PW0112-Mapleton Storm

MAPLETON CULVERT REPLACEMENT

Cross-Section A-A: Water Line Re-Locate

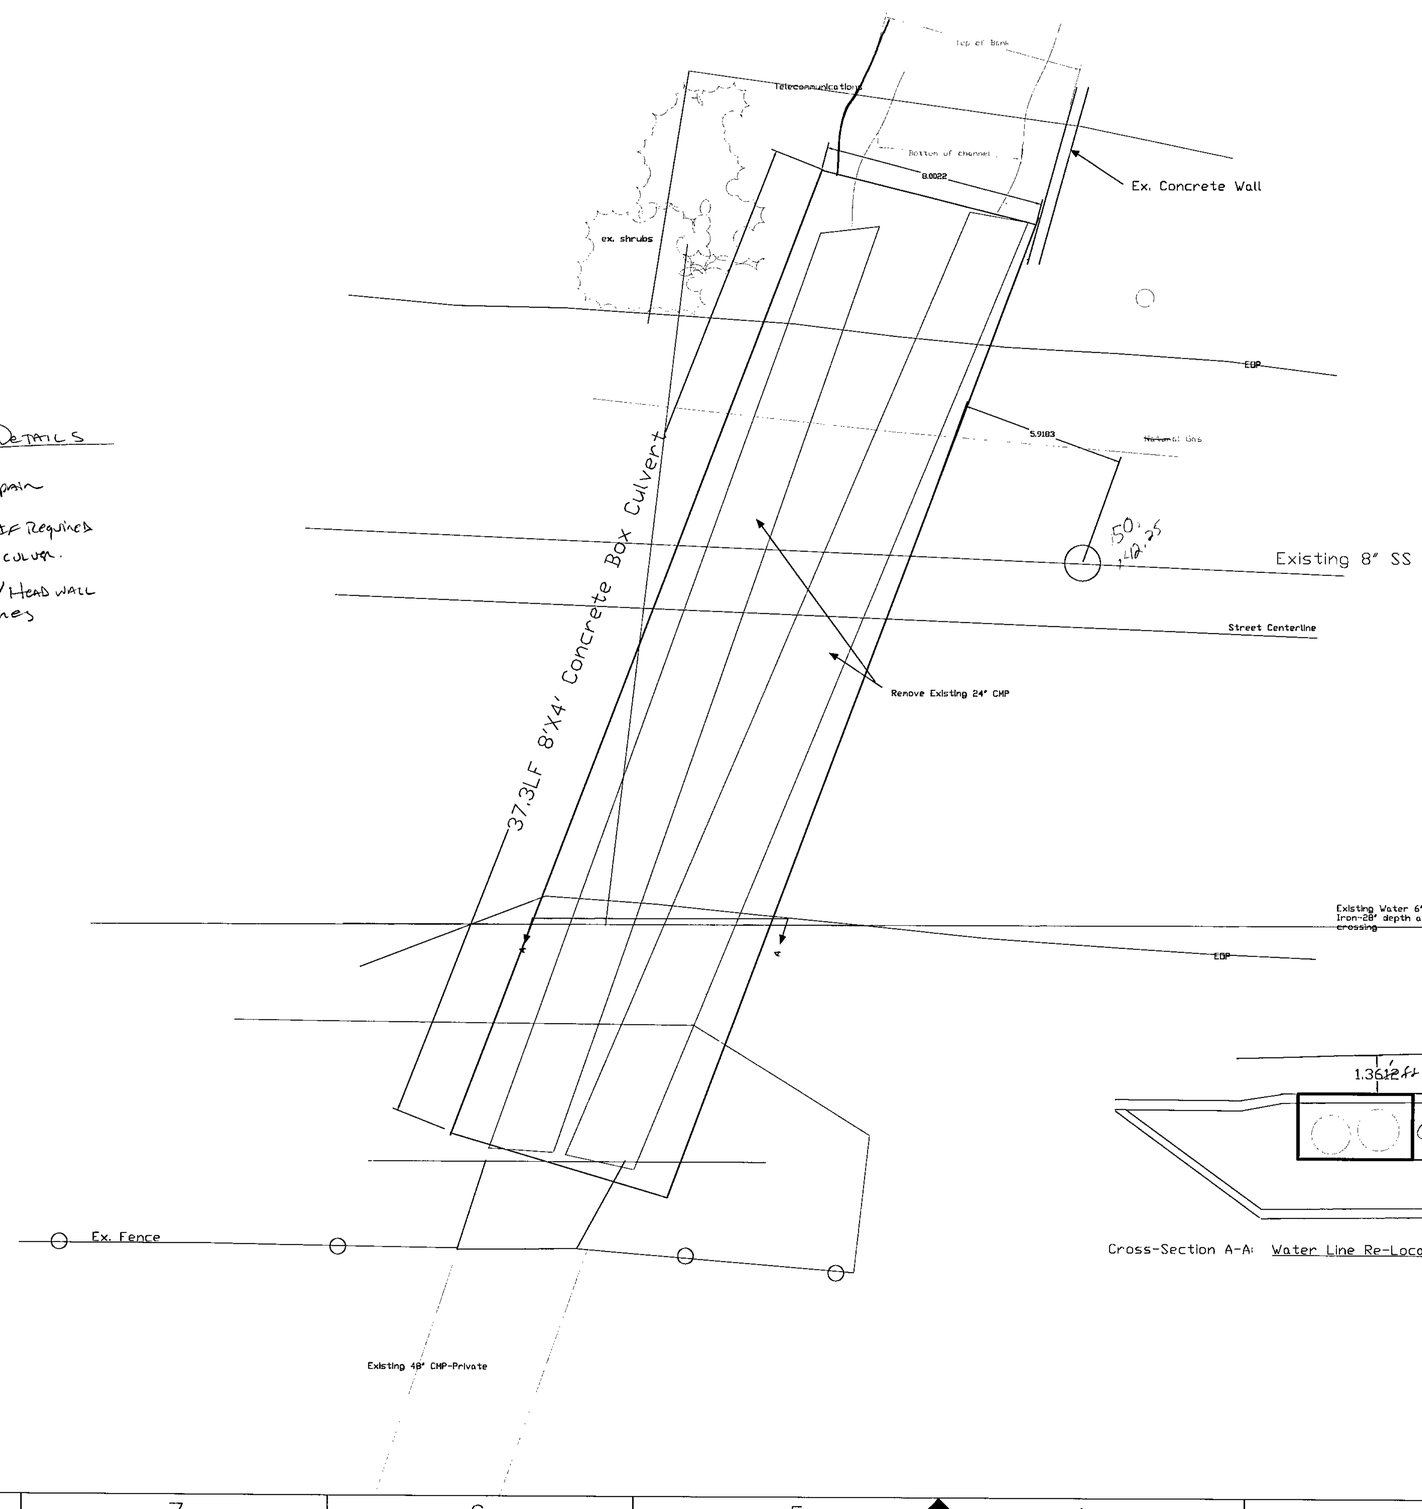
Required Details

- Street Repair
- Footing if Required for Box culvert.
- End wall / Head wall structures

1. Stream Flow By-pass: Coffer Dam shall be installed upstream of inlet. Direct Stream flows thru exist culvert as avail. thru. Etz —
2. Remove Existing CMP, including demo of concrete headwall, end wall structures,
3.

Lock In prop. corners —

Crosssection A-A

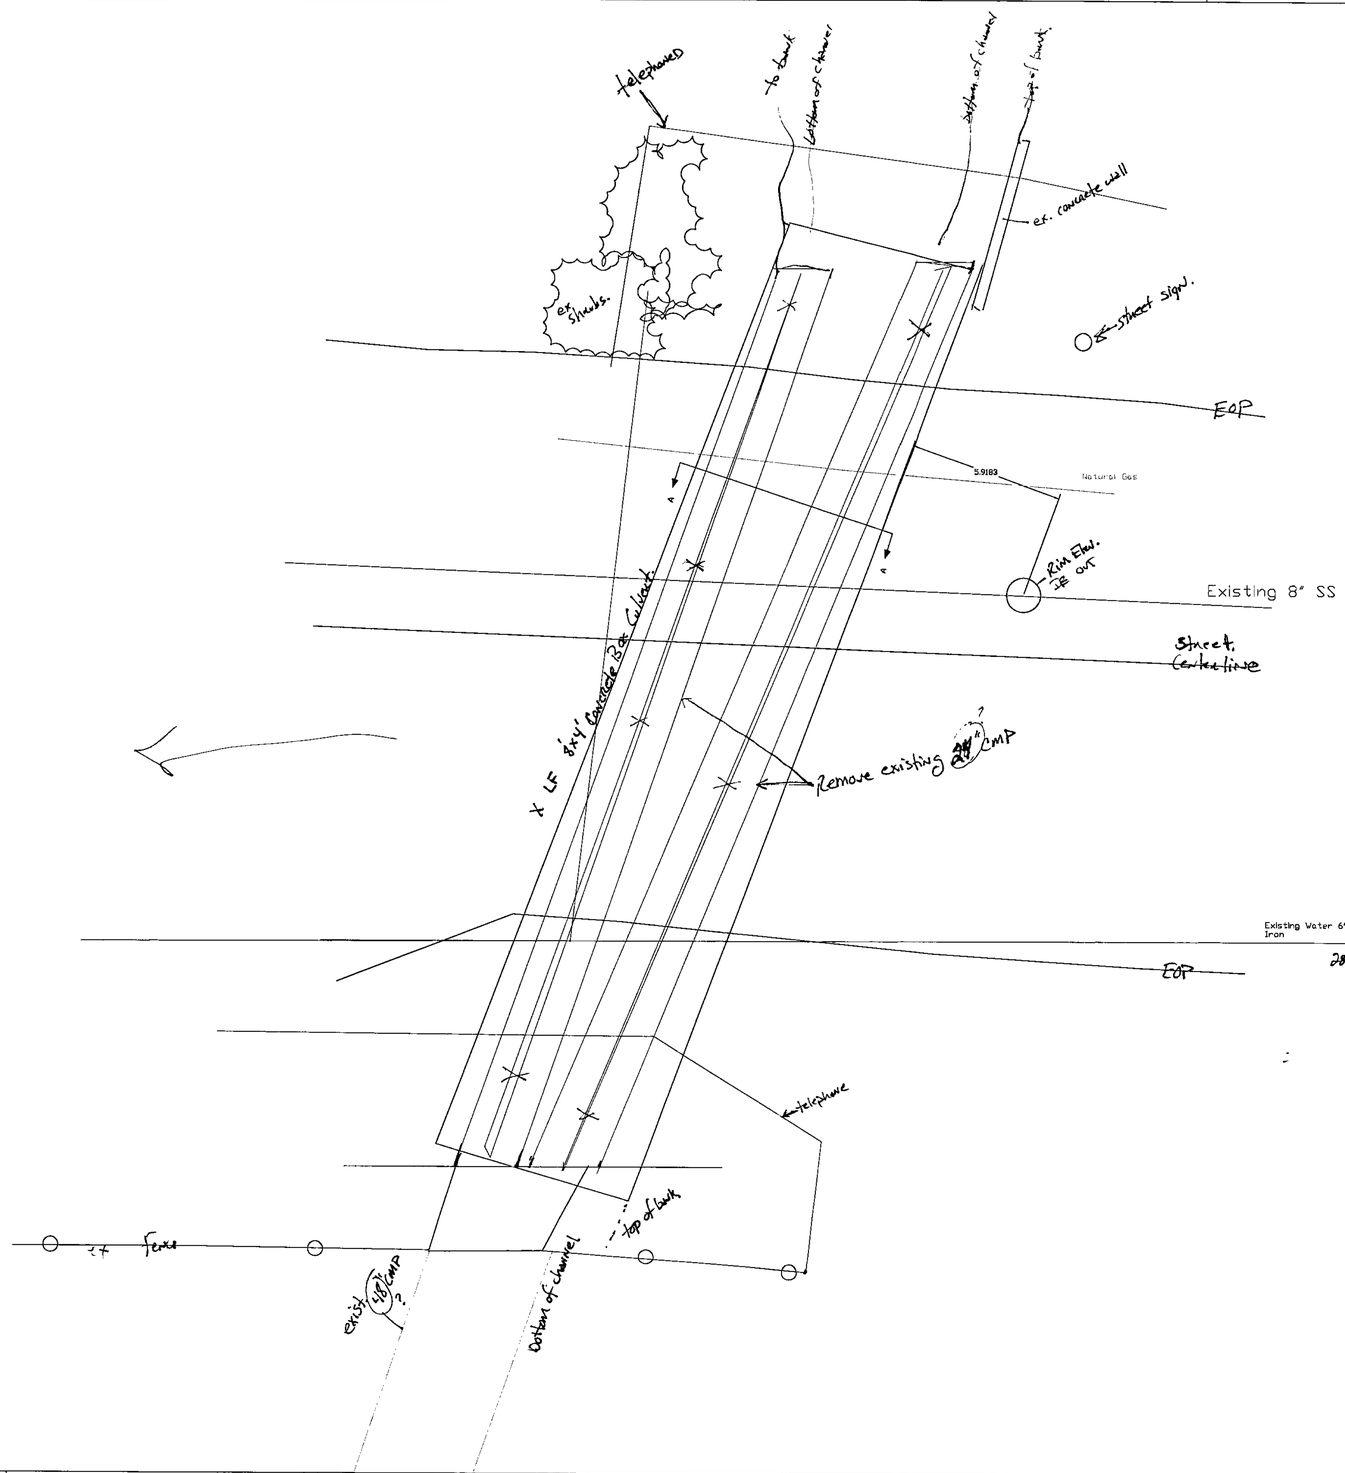
scale?
North Arrow.

GET SCALE
